Project Name : Posbrook Lane, Titchfield
Job No : 19-241
Note Title : Highways Response Technical Note
Author : MS
Checked : BM
Approved : BM
Date : January 2020

- 1.1 This Highways Response Technical Note (TN) has been prepared in response to comments made by Hampshire County Council (HCC) pertaining to the Outline Planning Application on Posbrook Lane, Titchfield (Ref: P/19/1193/OA); refer to **Appendix A**.
- 1.2 The site was subject to a previous Outline Planning Application (Ref: P/17/0681/OA) in 2017, which was refused and subsequently dismissed at Appeal. It should be noted though that there were no highways objections raised as part of this application and that the access proposals being submitted as part of the current application are the same as those for the Appeal scheme.

Job Title	POSBROOK LANE, TITCHFIELD	Scale	1:500	Date	SEPT 19	Designed	SD
Drawing Title	PROPOSED SITE ACCESS	Drawn	SD	Checked	MS	Approved	RJH
Client	FOREMAN HOMES	Job No	19-241	Drawing No	19-241/003	Rev	B

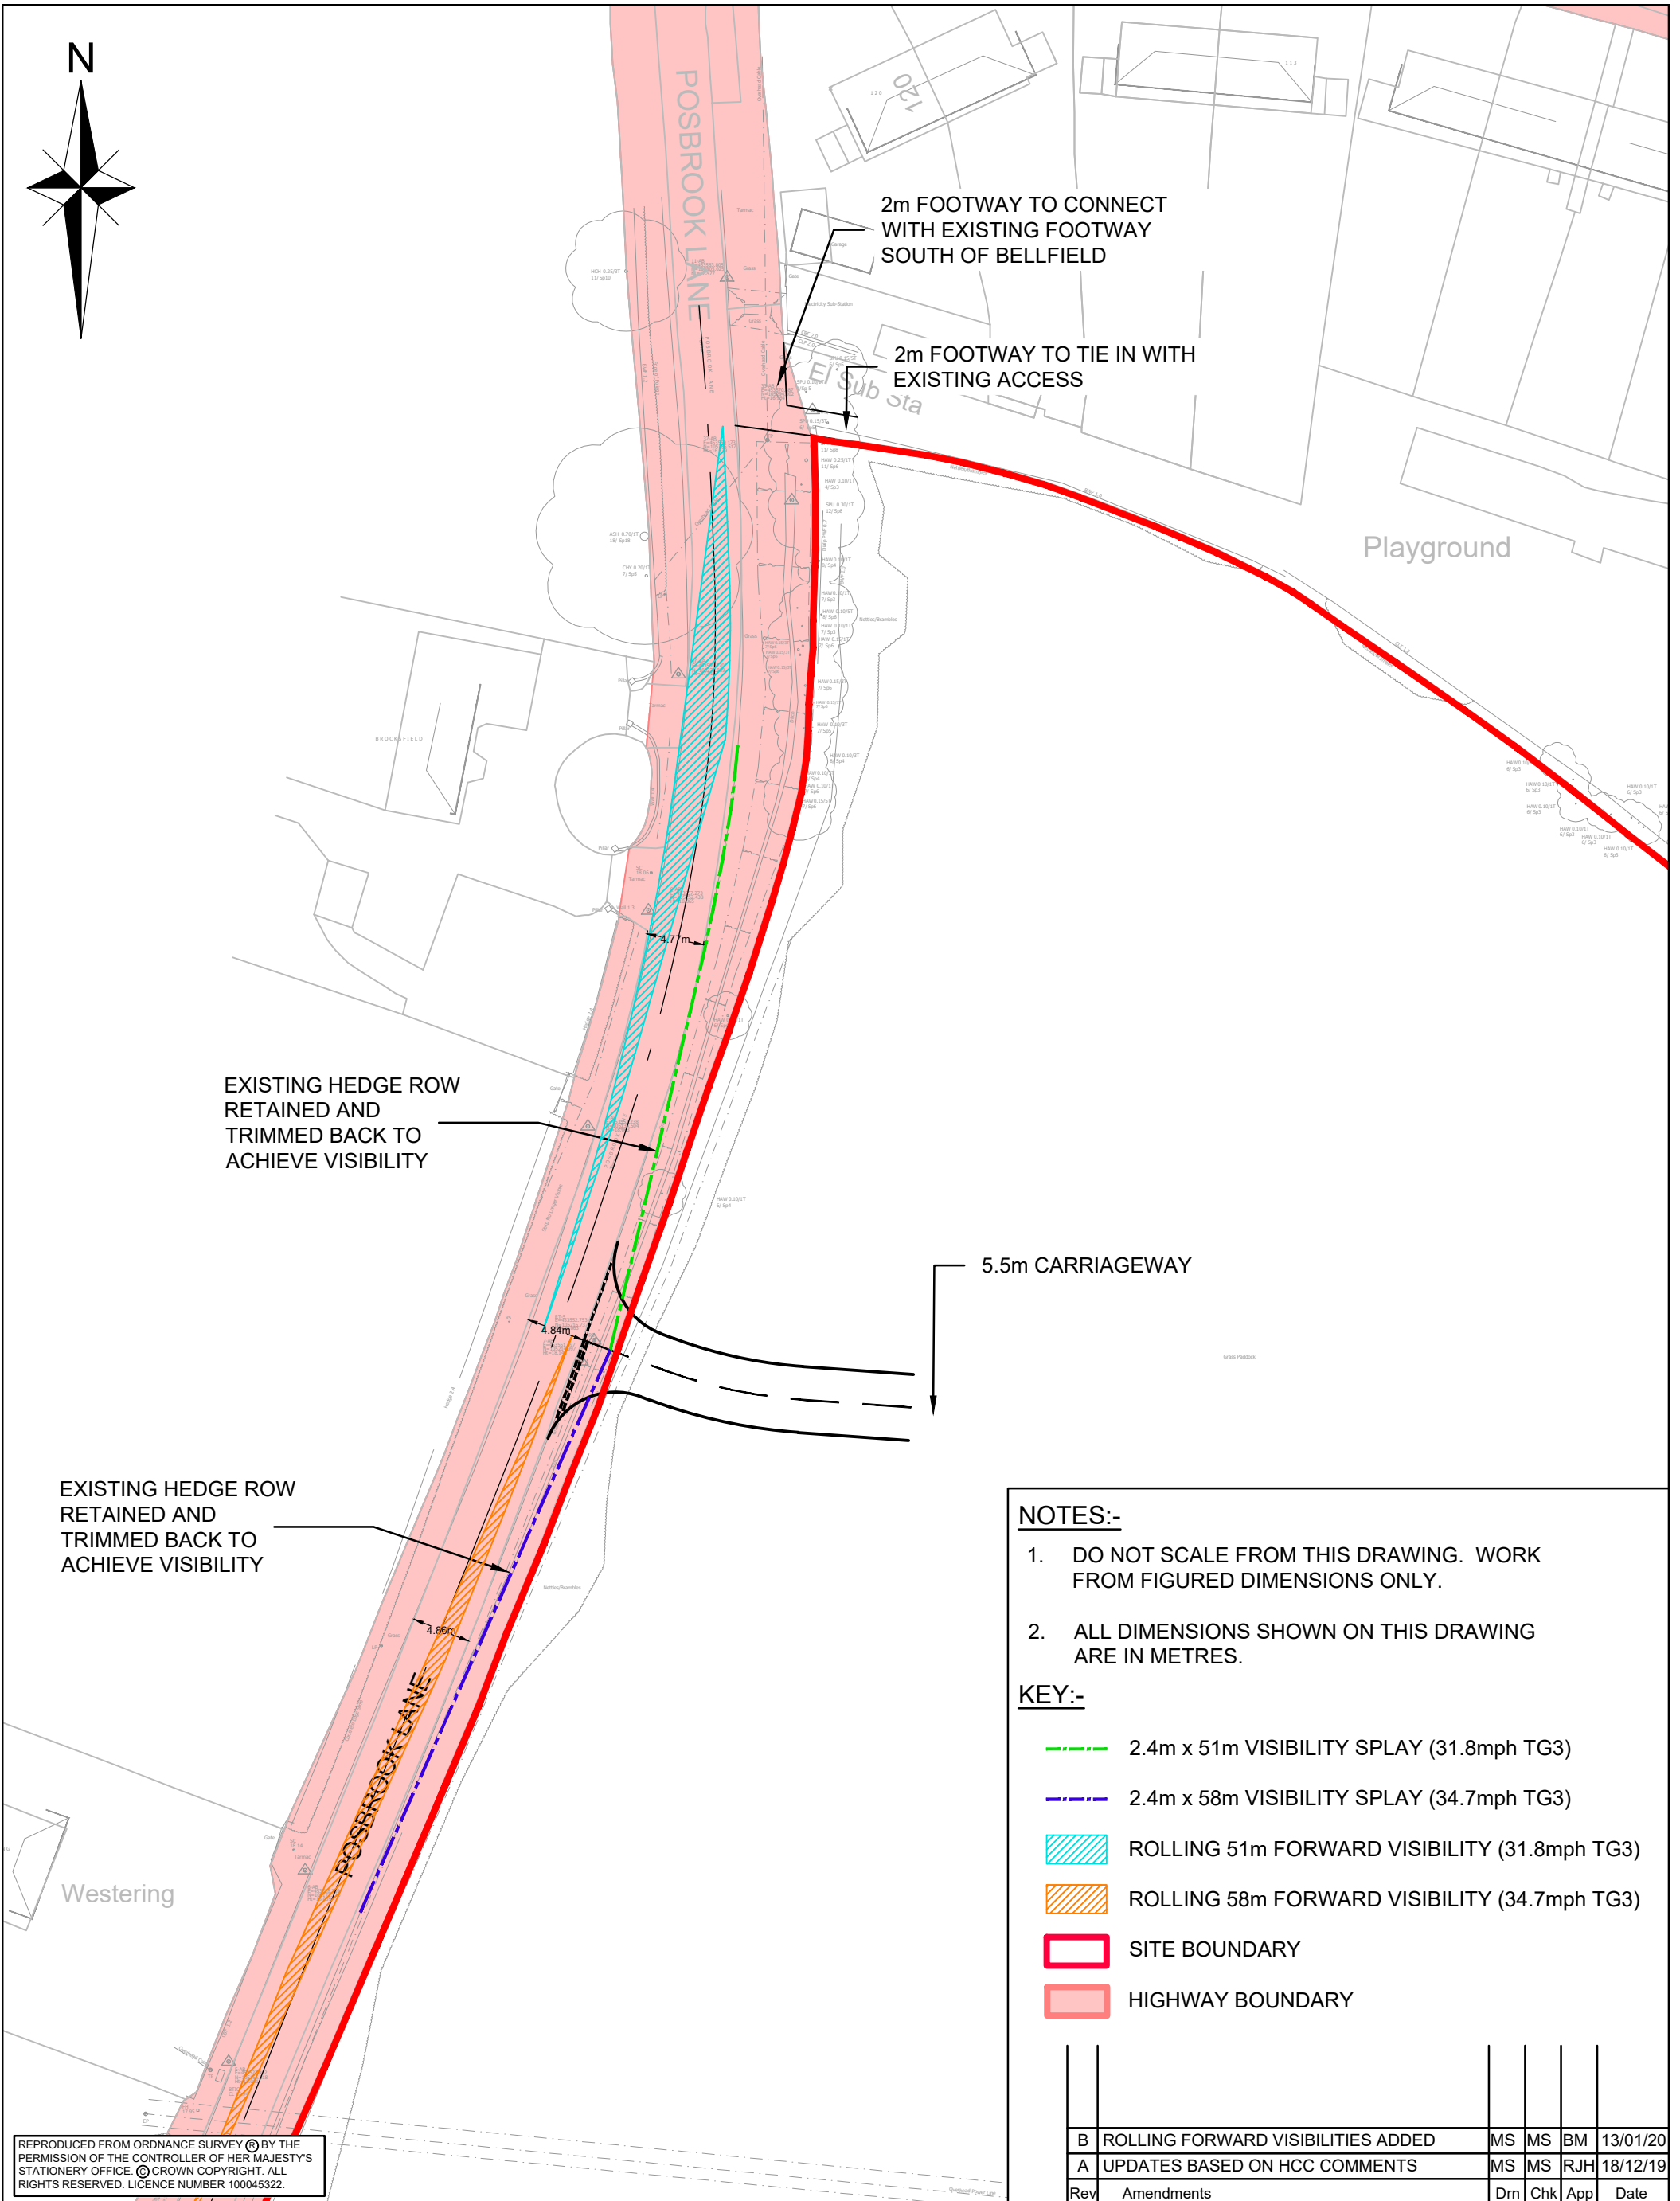
“The proposed footway on the eastern side will have issues for construction as there is an existing sub-station, residential access plus earth bank. The existing drainage looks to be weir kerbs draining directly into a highway ditch. It is anticipated that the drainage will require upgrading and there will be a need for Ordinary Water Course consent for the works to the highway ditch”.

“Since the previous application, TG3 has been published and based on the 85% speeds taken from 2016 the following visibility splays are required: -

- ***Northbound – 34.7mph, using $t=1.5$, and HGV’s (the road accessed farms to the south so these vehicles do use it plus tractors/combines harvesters) gives and SSD of 58m.***
- ***Southbound – 31.8mph, using $t=1.5$, and HGV’s (the road accessed farms to the south so these vehicles do use it plus tractors/combines harvesters) gives and SSD of 51m.***

Therefore the 47m splays shown on drawing 19-241/003 are insufficient and subsequently there will be more impact to the hedge row/trees along the boundary (some private/some highway). There will be need to ecological surveys for loss of hedge row, as well as a CAVAT assessment as highway trees will be lost.”

“Forward visibility should also be considered along Posbrook Lane. For traffic travelling north, at a point 87m south of the centre line of the junction, a vehicle needs to see 58m in front of them in a rolling forward dimensions. For south bound traffic, the point is 76.5m with a 51m rolling dimension.”

- 2.3 The proposed footway is to be set within the site behind the earth bank and trees, with the connection point being shown on **Drawing 19-241/003B**. This ties into the back of existing

highway boundary south of the location of the electricity substation and will, therefore, have no impact on its current location. The earth bank that is adjacent to the substation has been deemed to be superfluous as highlighted in Paragraphs 2.4 to 2.6 of the Highways Response Technical Note (Report 16-314-05 dated 31 August 2017) submitted as part of the previous Planning Application.

2.10 The above comment is noted and has been taken on board. **Drawing 19-241/003B** shows the updated visibility splays. As can be seen on this updated drawing, the changes to the visibility splays have minimal further impact on the hedge row/trees along the boundary.

2.12 Forward visibility has also been added to **Drawing 19-241/003B**.

Job Title	POSBROOK LANE, TITCHFIELD	Scale	1:500@A3	Date	JAN 20	Designed	MS
Drawing Title	SWEPT PATH ANALYSIS - MAX LEGAL ARTIC	Drawn	MS	Checked	MS	Approved	BM
Client	FOREMAN HOMES	Job No	19-241	Drawing No	19-241/005	Rev	-

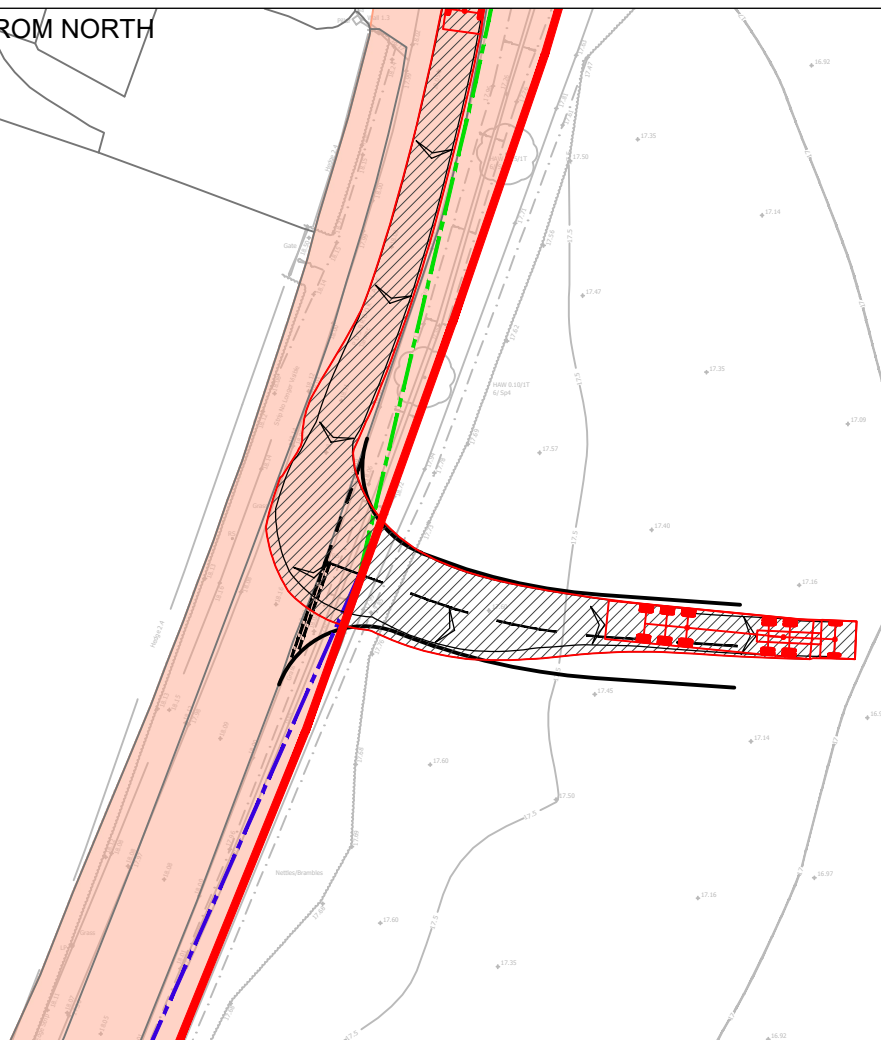
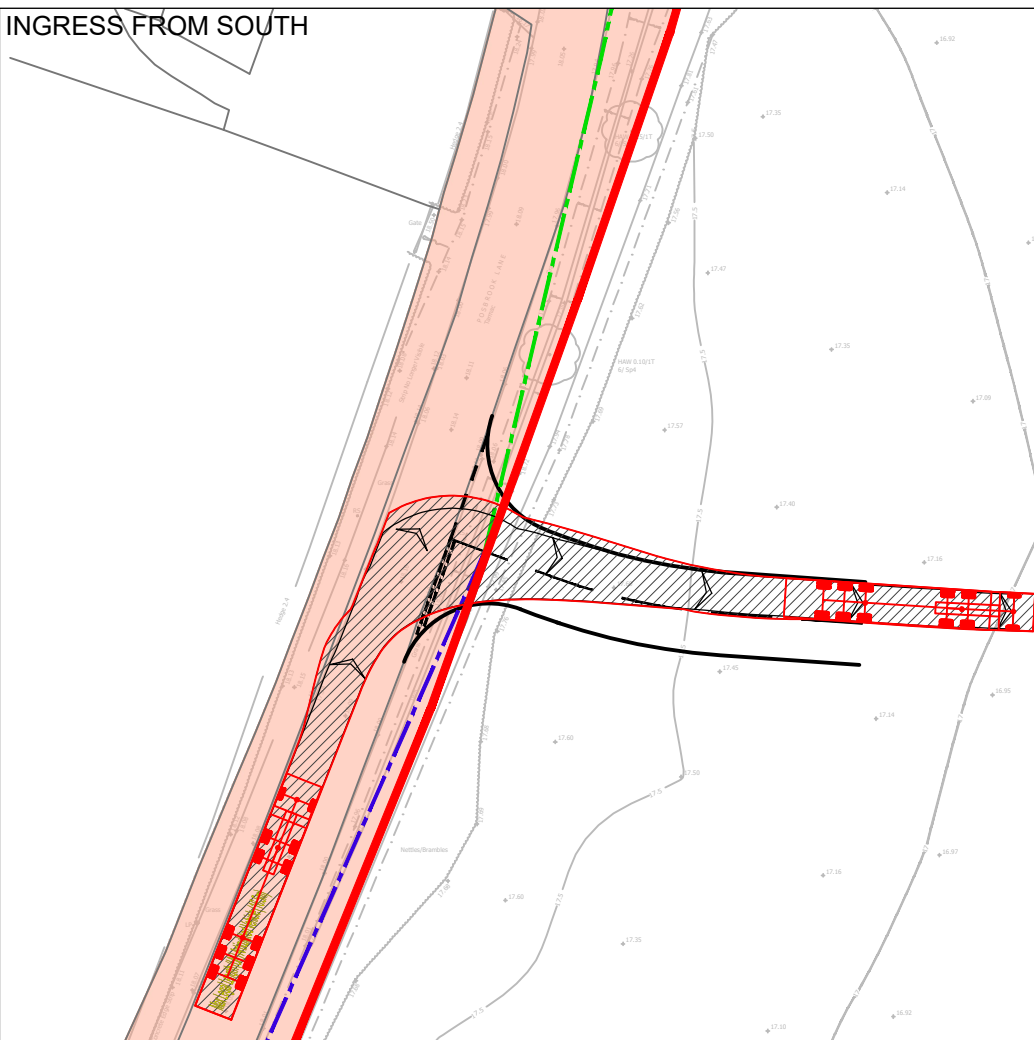
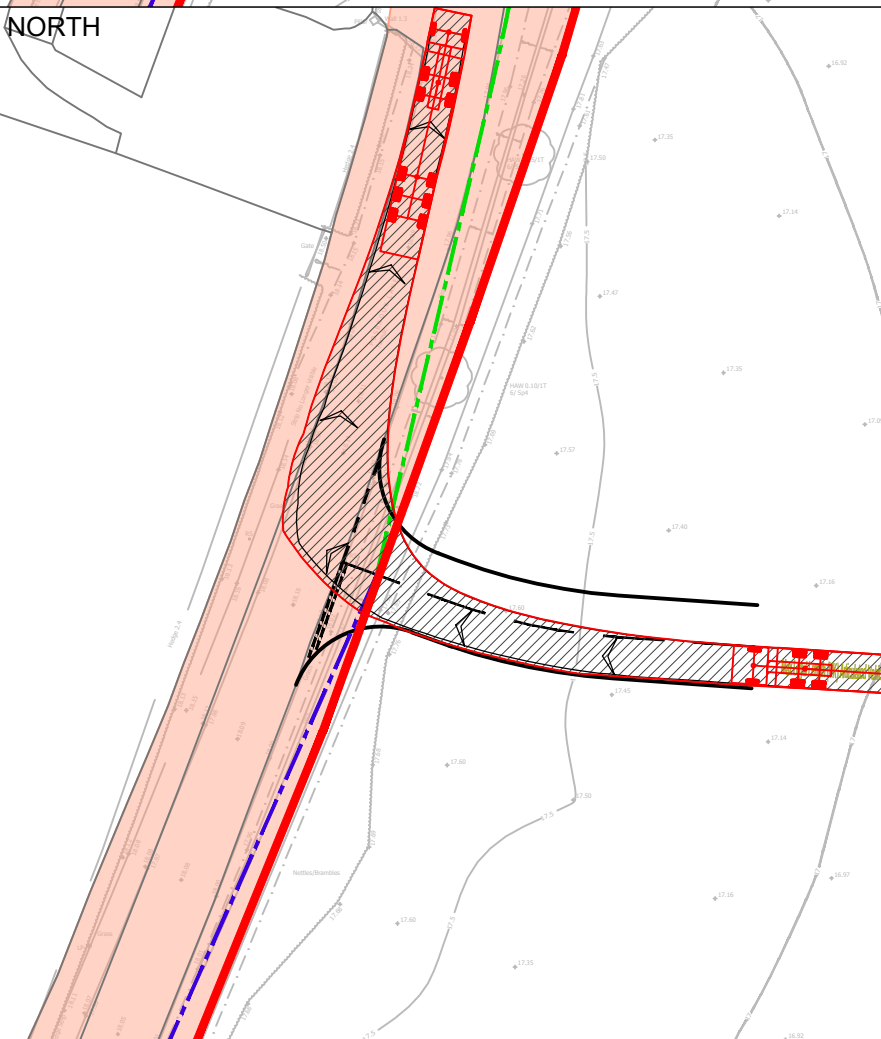
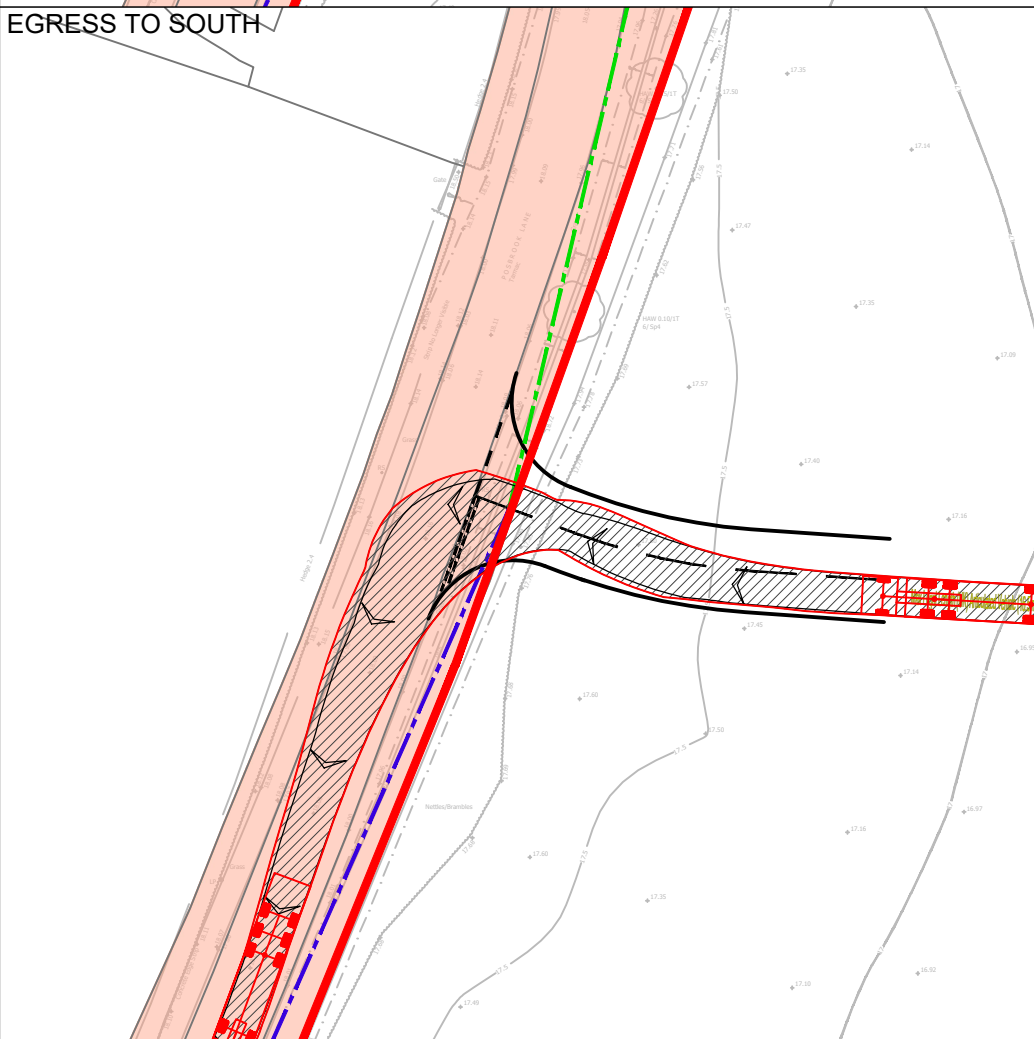
“With regards to vehicle tracking, a super large refuse vehicle should be used (11.m long x 2.53 wide) plus an artic lorry as it is assumed that the access will be used for construction traffic.”

2.7 It is deemed that given the site proposals, there will not be a need for an articulated lorry to access the site; however, for completeness swept path analysis showing an articulated vehicle accessing the site is shown on **Drawing 19-241/005**.
